**Addendum No. 2**

**For Project No. ENG2403730319  
Lincoln Amphitheatre Improvements  
Lincoln State Park  
Spencer County**

Re: Lincoln Amphitheatre  
Phase 3&4 – Amphitheatre Improvements  
Lincoln City, IN  
Project #: LA23102  
DNR Project #: ENG2403730319

## **ADDENDUM #2**

DATE: 3-8-24  
 REV: 4-1-24  
 LDA PROJECT NO.: LA23102  
 ENR PROJECT NO.: ENG2403730319  
 SHEET NO.: A5

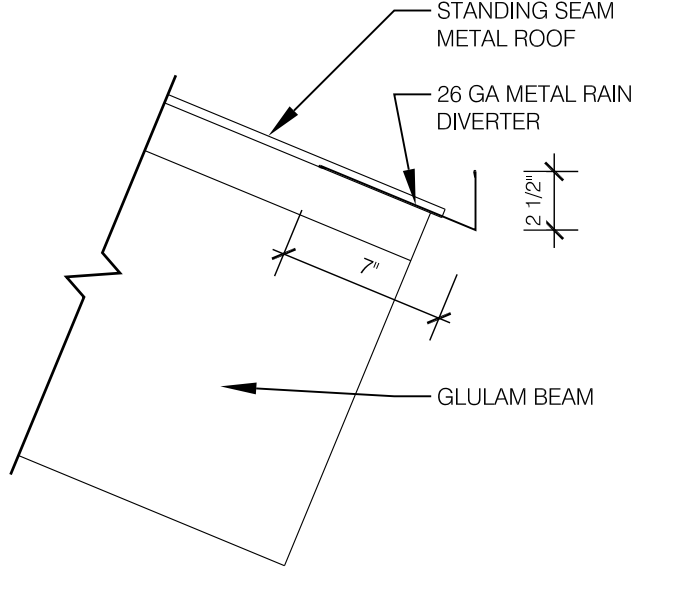
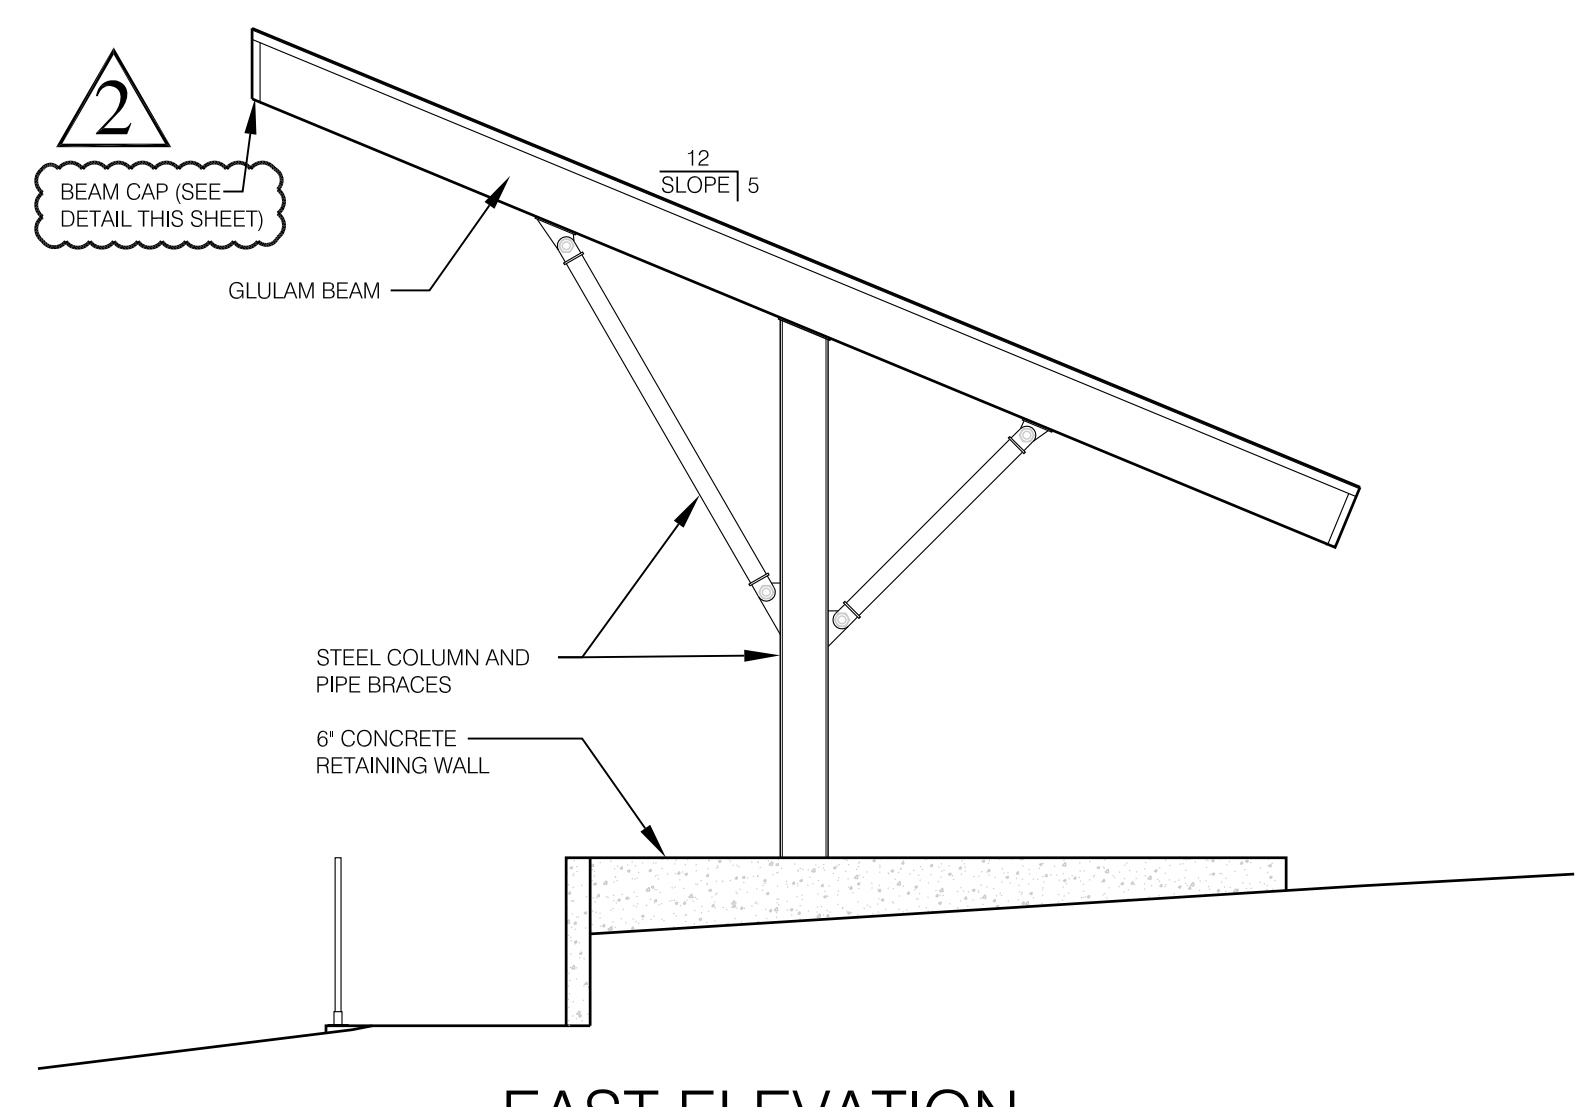
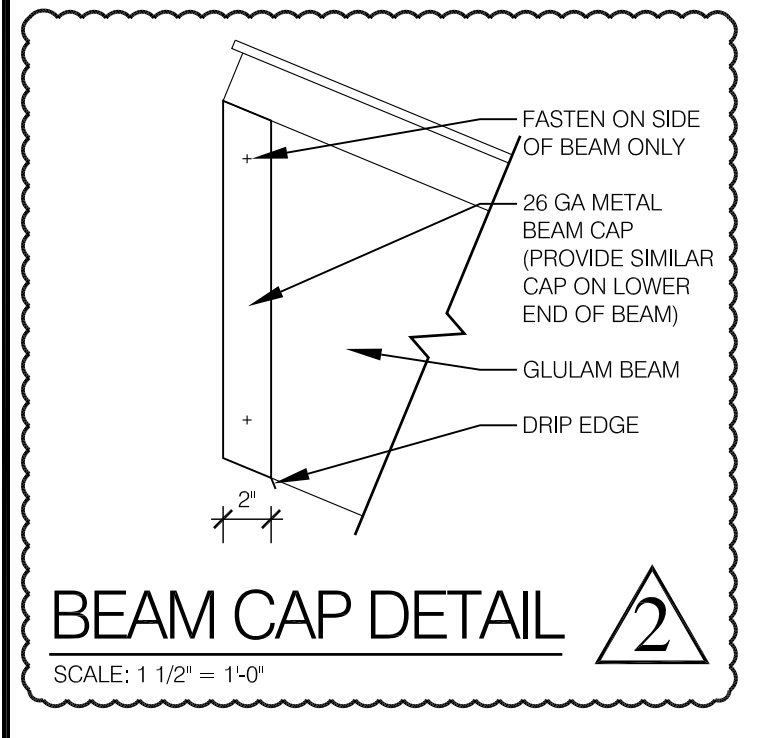
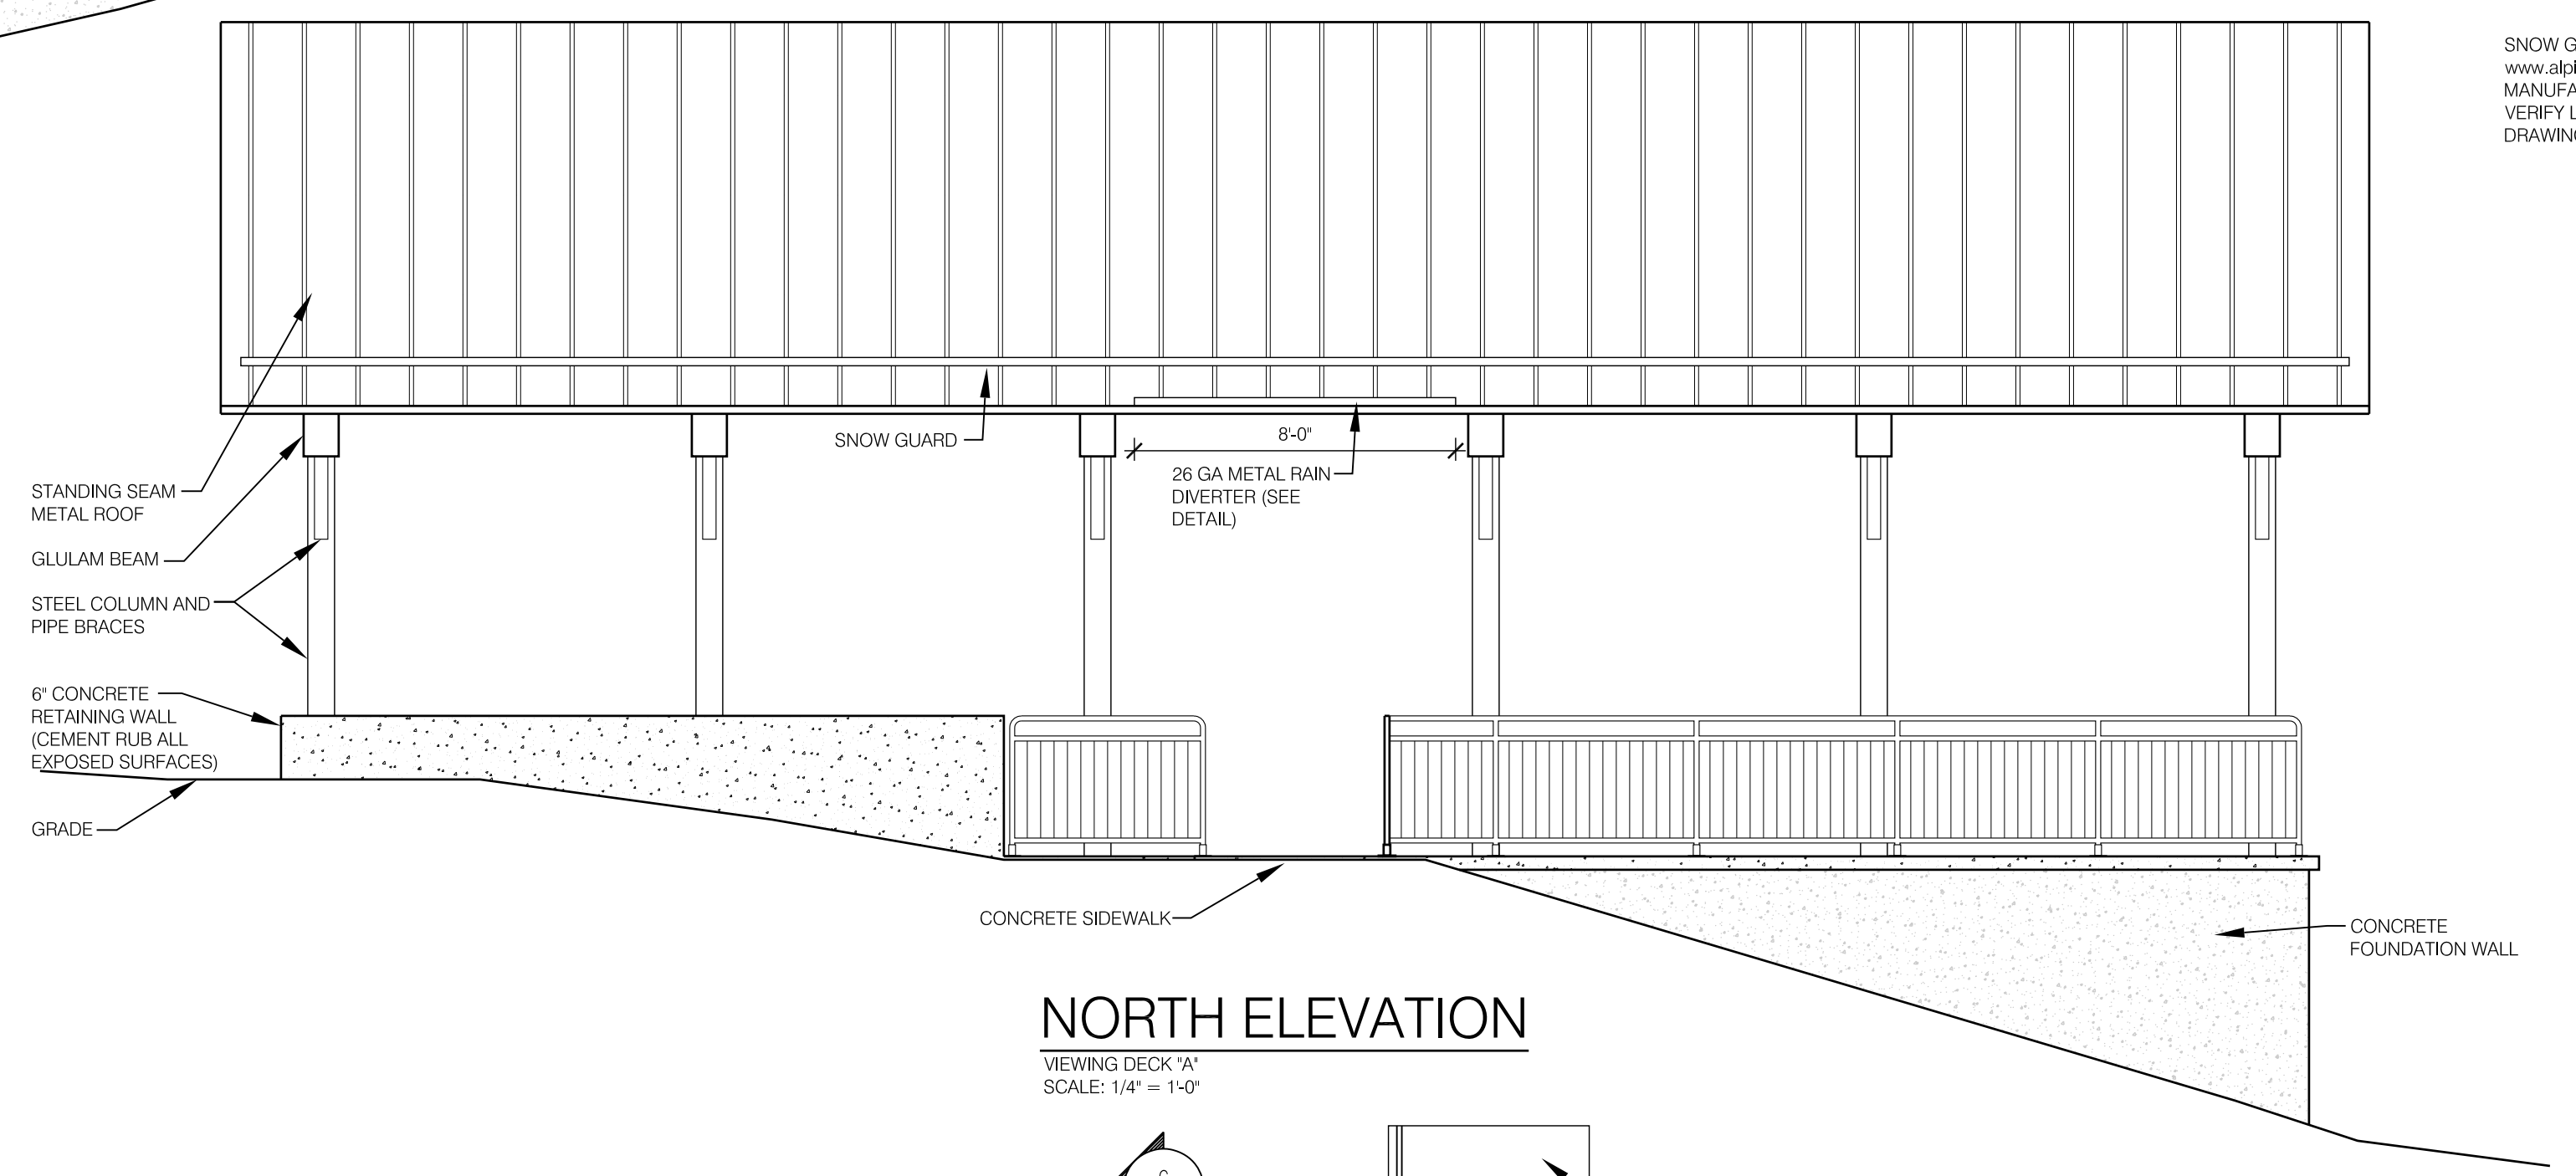
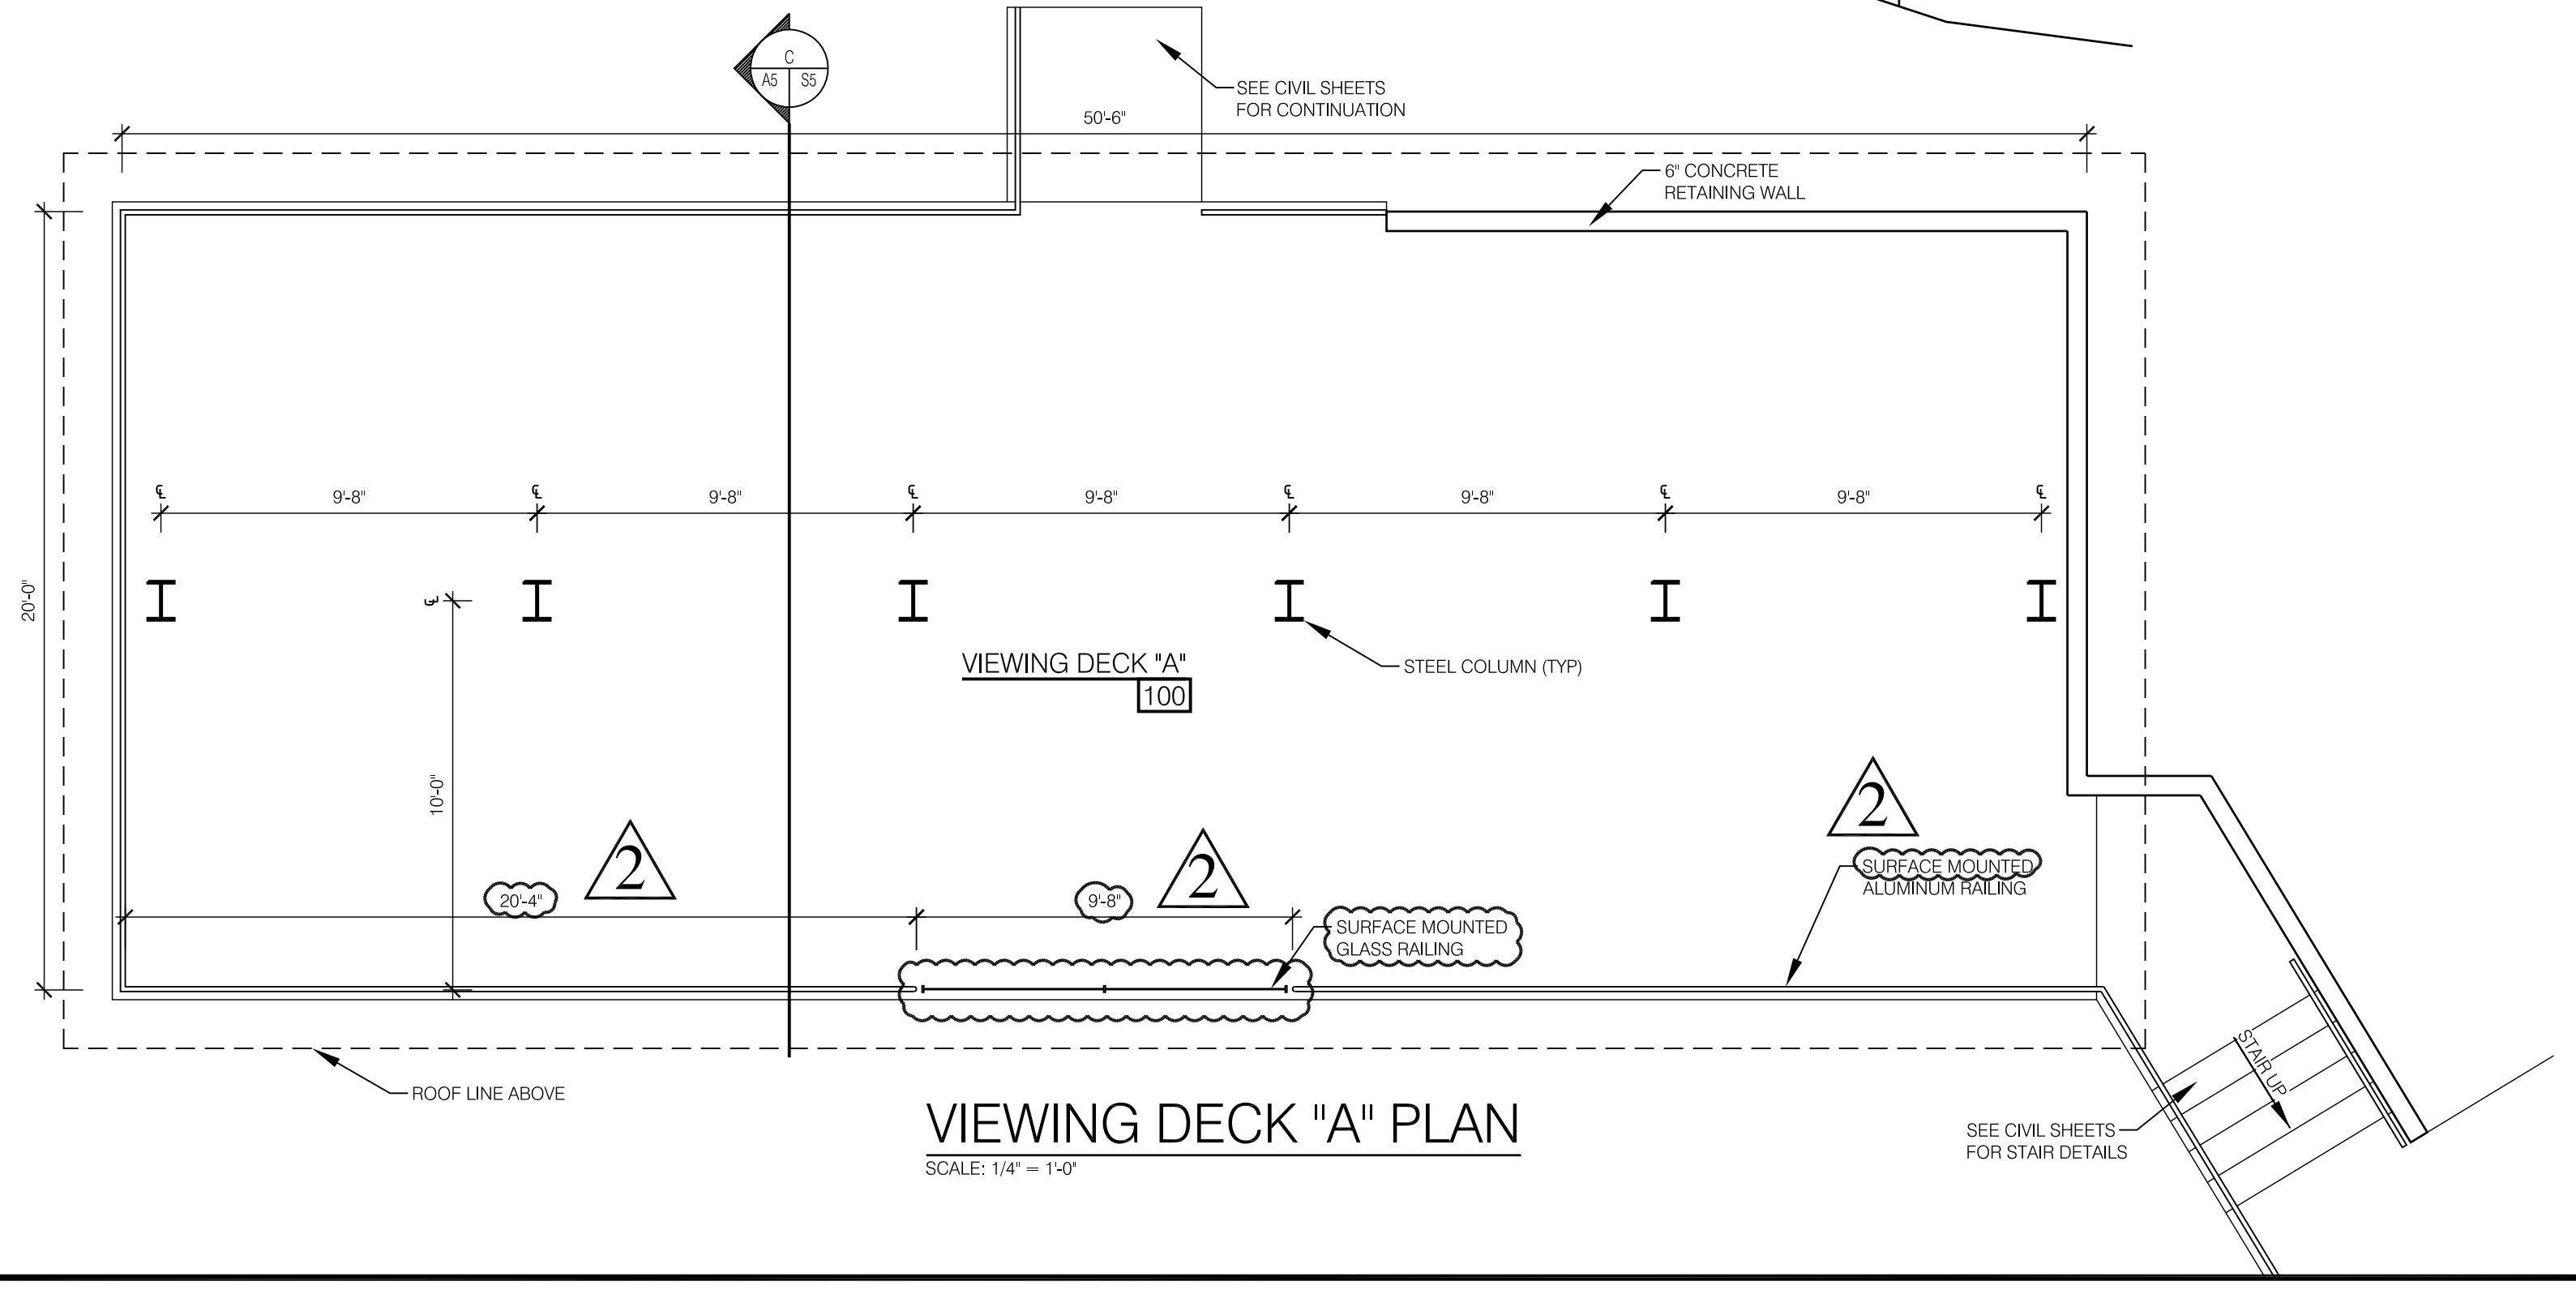
10. Sheets A5 & A6 – See the revisions as shown on the revised sheets included with this document. The revisions relate to dimensions for the glass railing as well as a beam cap flashing detail at the ends of all of the glulam beams.
